No. EC120-32-009

SERVICE BULLETIN

LANDING GEAR

New binding clamps of the landing gear fairings

Figure 1

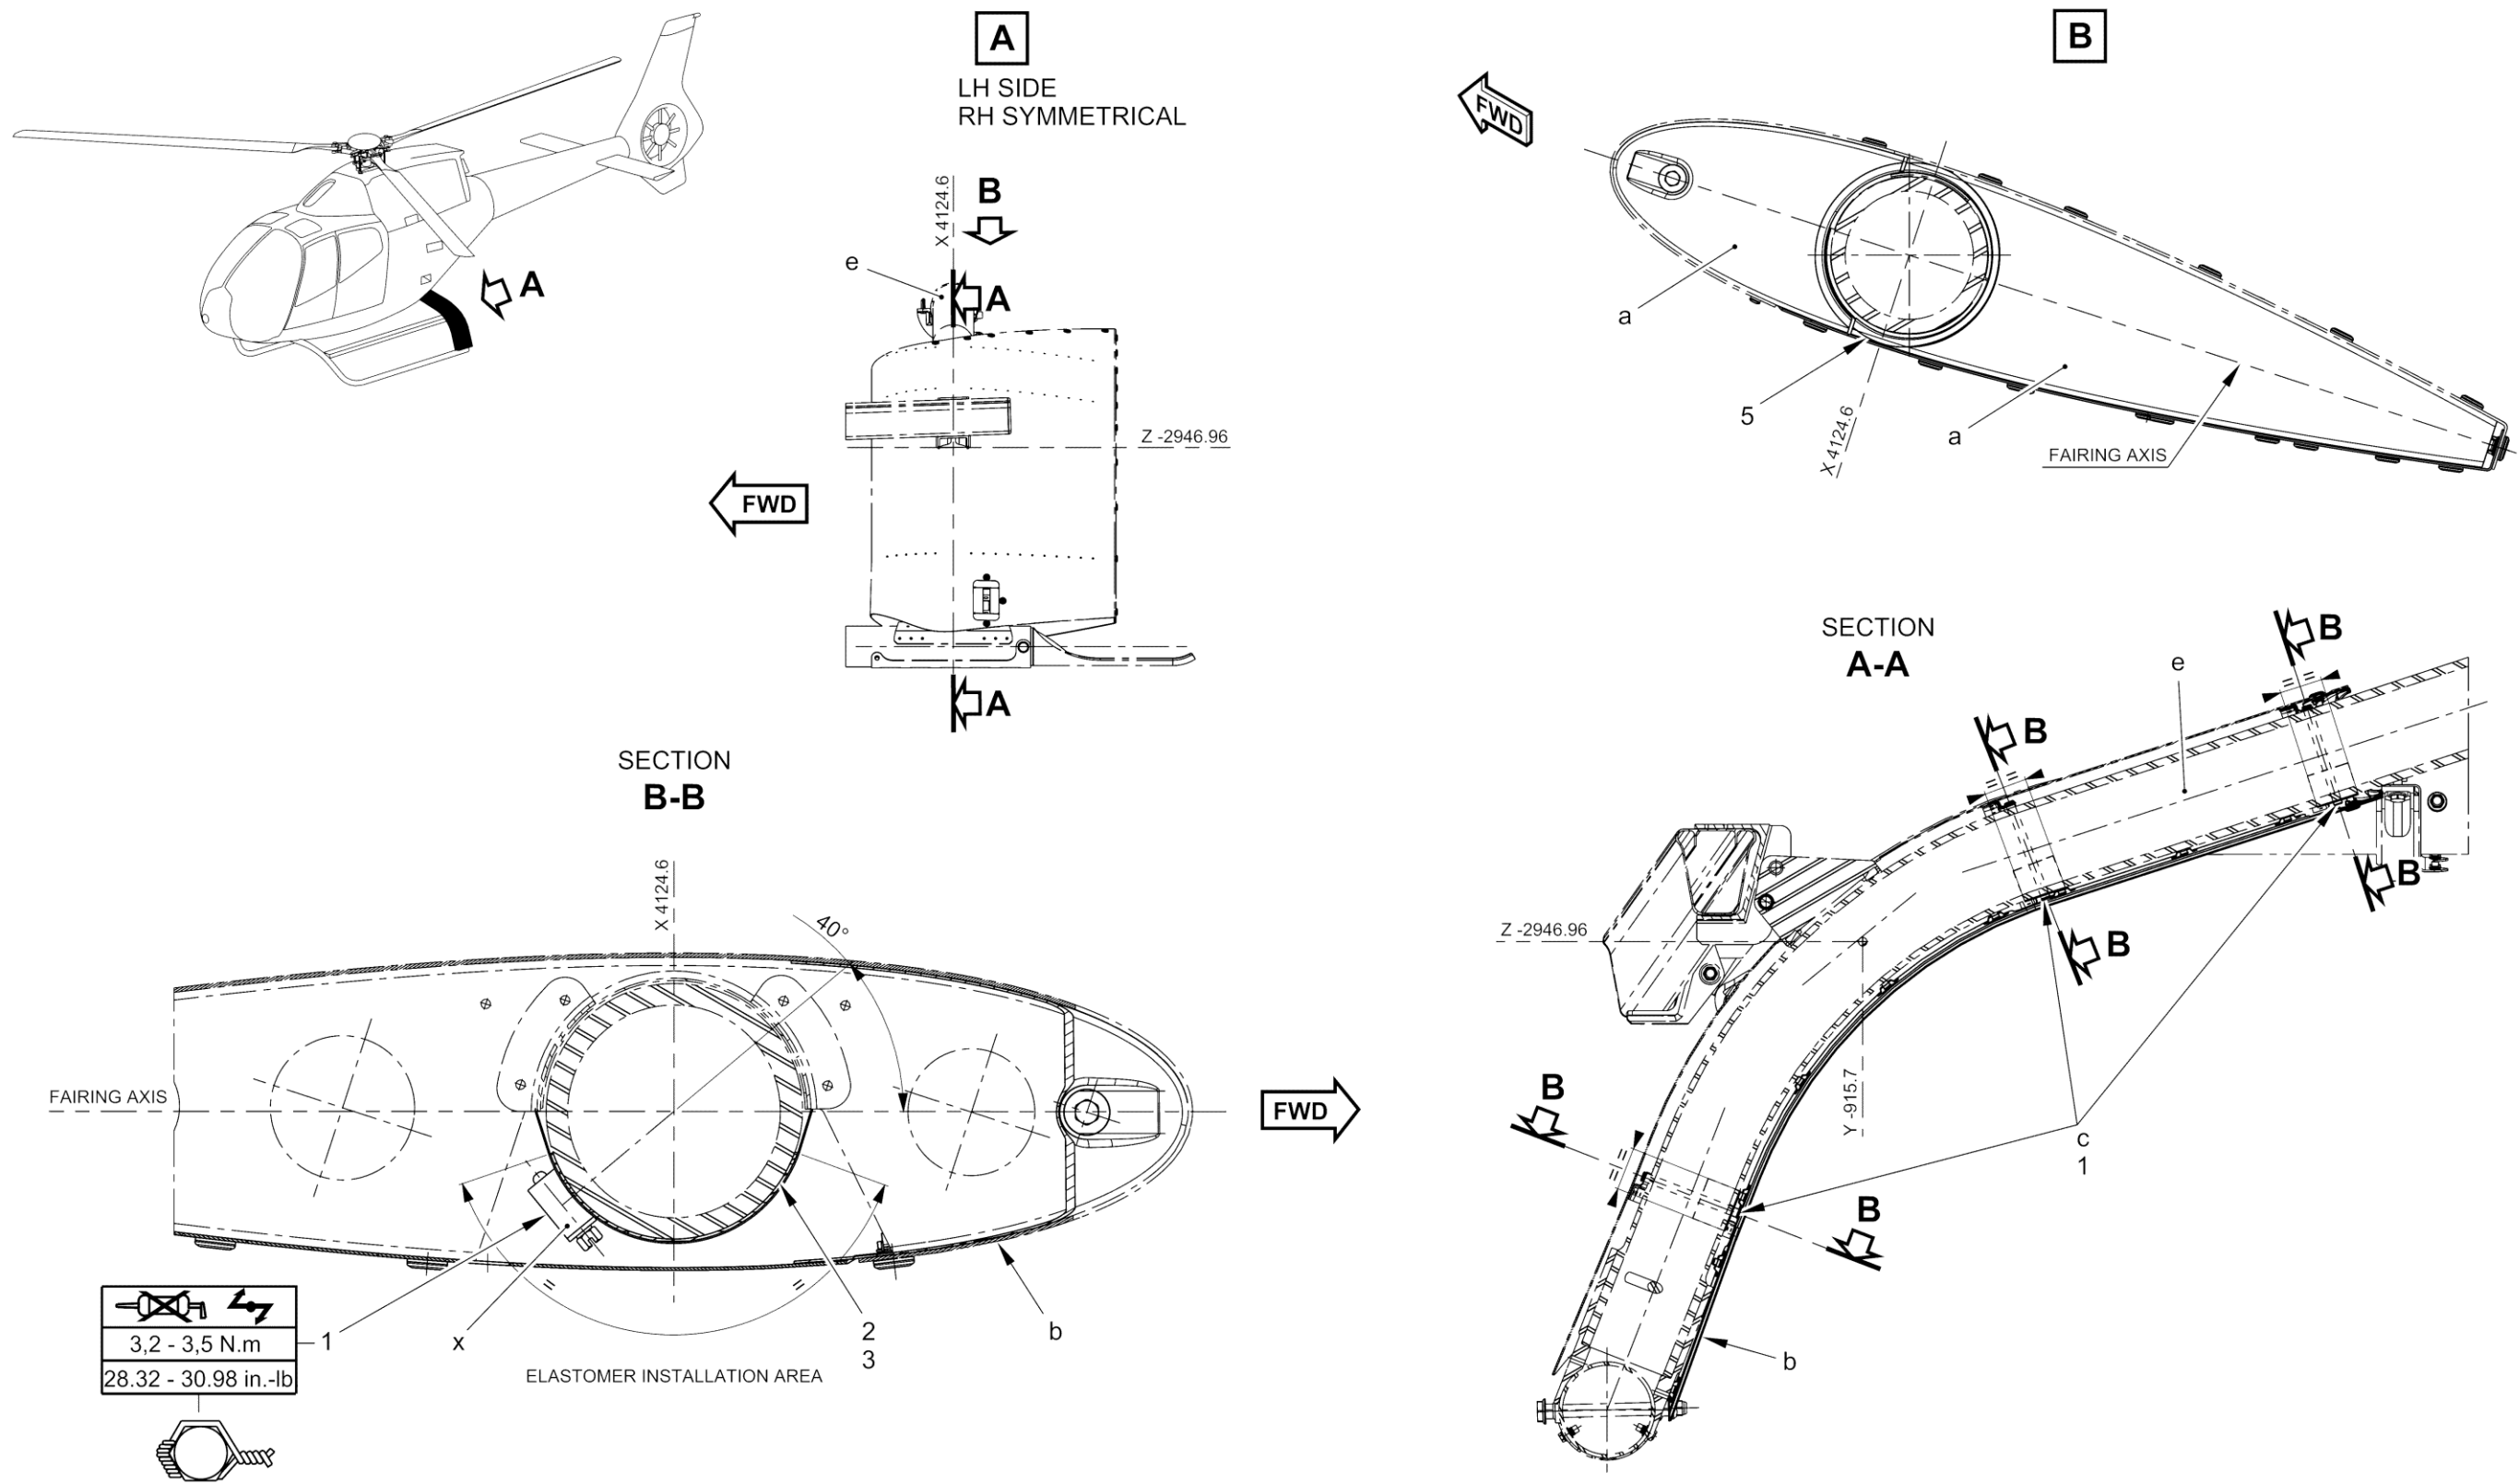
During the landings/takeoffs, the landing gear tube undergoes a significant movement, thus the binding clamps undergo the same movement. After the rupture of the clamp, the fairing moves in flight as a result of aerodynamic loads. Thus, marks can appear on the tube.

This Service Bulletin consists in removing the binding clamps from the fairings and installing new binding clamps on the landing gear fairings.

- Remove the blanking caps (a) and keep their hardware (Detail B).
- Remove the lower fairing (b). Refer to Task 32-12-00, 4-1 (AMM) and keep its hardware (SECTIONS A-A and B-B).

- Remove and discard the clamps (c).
- If necessary, discard the elastomer (not shown) positioned between the clamps (c) and the landing gear tubes (e) (SECTION A-A).

- Position the elastomer plates (3) in the center of the landing gear (e) at each clamp (1) marker and cut to length. Refer to dimensions (SECTIONS A-A and B-B).
- Bond the elastomer plates (3) on the landing gear tube (e) using the adhesive (2).
- Install the clamps (1) in place of the clamps (c).

The screw support unit (x) must be positioned depending on the position of SECTION B-B.

- Tighten the clamps (1) to contact.
- Position the lower fairing (b).
- Make sure that it does not interfere with any of the clamps (1).
- Tighten the clamps (1) to the indicated torque value.
- Safety using lockwire (4).
- Install the lower fairing (b) using its hardware. Refer to Task 32-12-00,4-1 (AMM).
- Cut to length and install the profile (5) on the internal edges of the blanking caps (a) (Detail B).
- Install the blanking caps (a) using their hardware.
